**Errata to  
Advanced Energy Design Guide for K-12 School Buildings—Achieving Zero Energy  
(2018)**

**September 20, 2018**

**Figure 5-3 Heating and cooling loads by climate zone.**

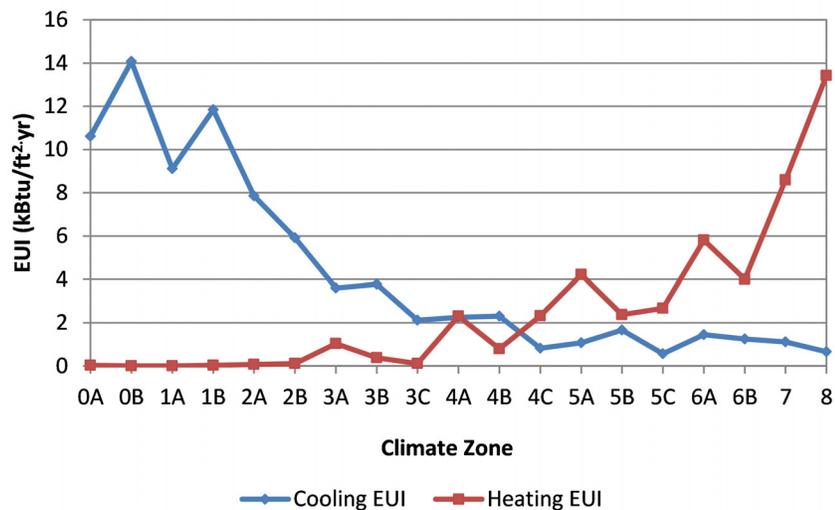
**Page 73:** Figure 5-3 should be replaced with the below corrected graphic. In addition, in the second to last sentence of the paragraph discussing Figure 5-3, the text currently reads “This information can be quite useful as an intuitive starting point as one starts to evaluate appropriate building strategies for a specific project and, more specifically, how climate in which a building is located changes the HVAC heating and cooling loads” but should read “This information can be quite useful as an intuitive starting point as one starts to evaluate appropriate building strategies for a specific project and, more specifically, how **the** climate in which a building is located changes the HVAC heating and cooling loads.”
